96N120 PH 6 SUBDIVISION PLAT

DATE DESCRIPTION
GREAT BASIN	B E N G I N E E R I N G C	5746 SOUTH 1475 EAST OGDEN, UTAH 84403 Main (801)394-4515 S.L.C (801)521-0222 FAX (801)392-7544 W W W . G R E A T B A S I N E N G I N E E R I N G . C O M	REV
Plan / Profile (Utility)	The Chalets at Ski Lake No. 7	A part of the Southwest 1/4 of Section 13, a part of the Northeast 1/4 of Section 23, and a part of the Northwest 1/4 of Section 24,	T6N, R1E, SLB&M, U.S. Survey
Not 166484 MARK EUGENE BABBITT Jan, 2012 SHEET NO.

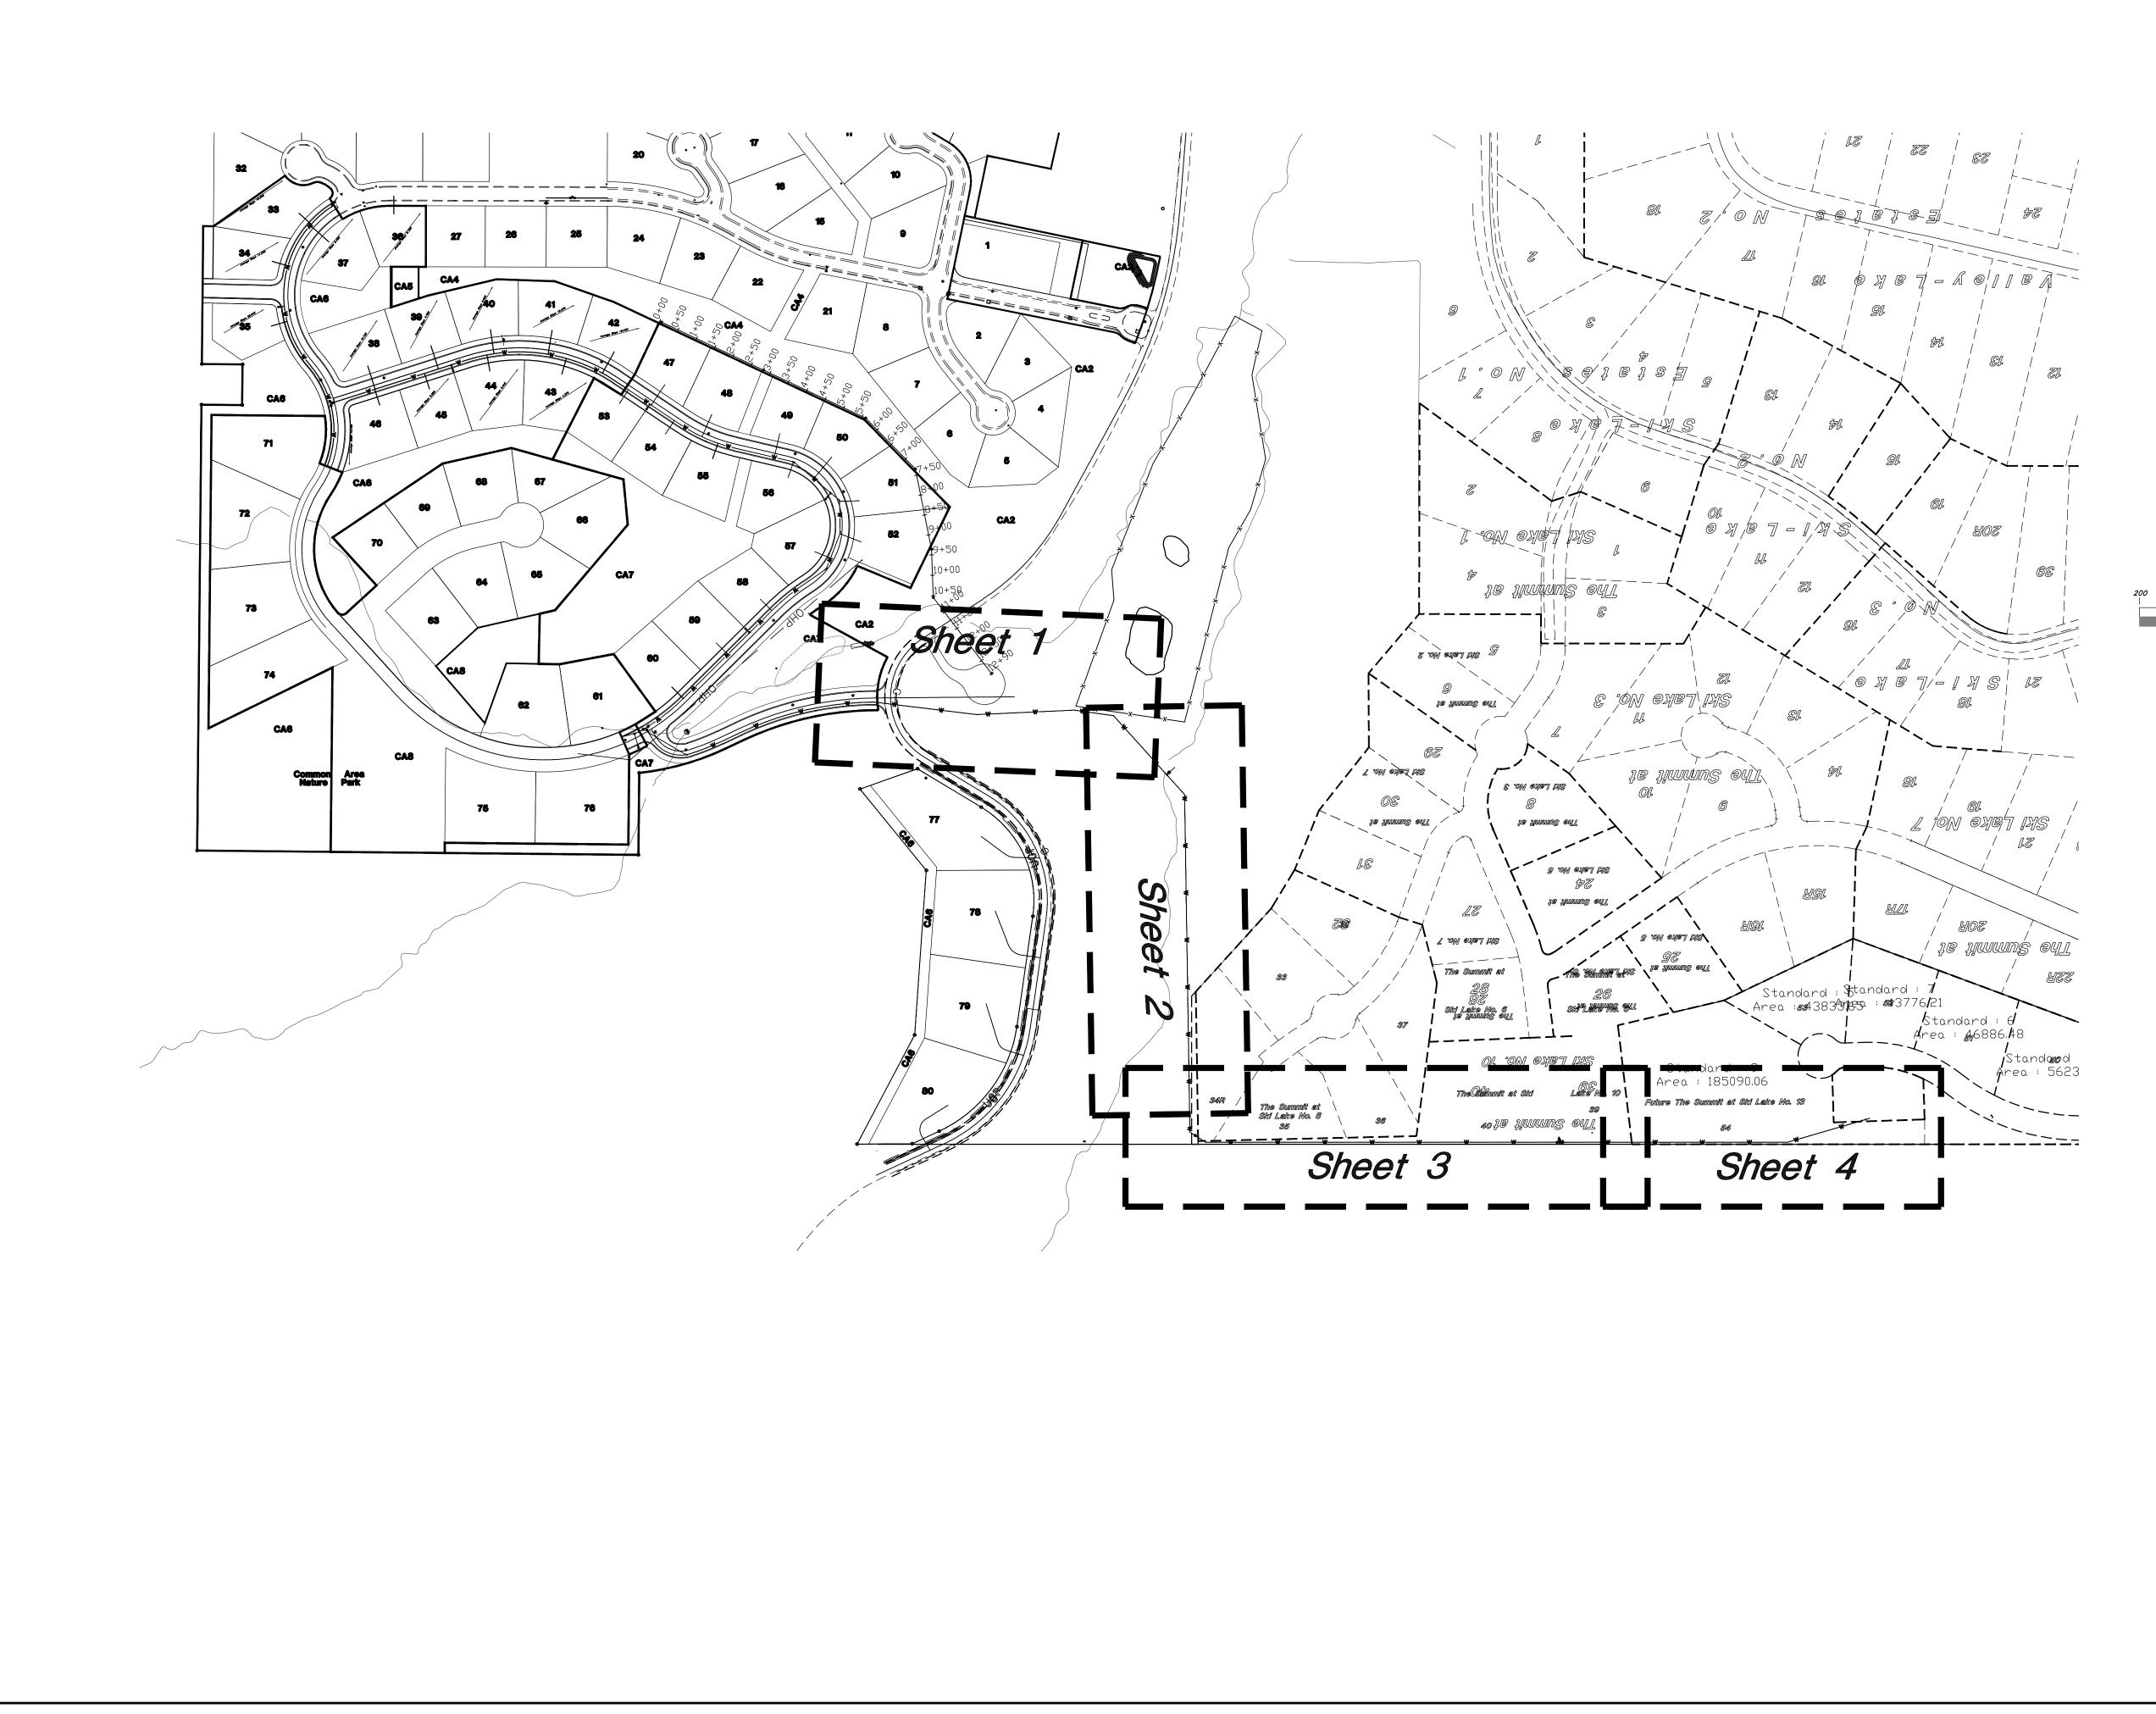
calling out possible issues here with this drainage. I think we need a Geotech to look at this area. R-Lots?? Does there need to be an easement?

An updated Geotechnical Report for Phases 7 and 8 that addresses this area is attached. Also included is a letter specifically about these two lots. This letter recommends natural slopes to be a maximum of 4:1. These two lots are an average of about 6:1 using a water drop analysis. Therefore, no additional measures are necessary
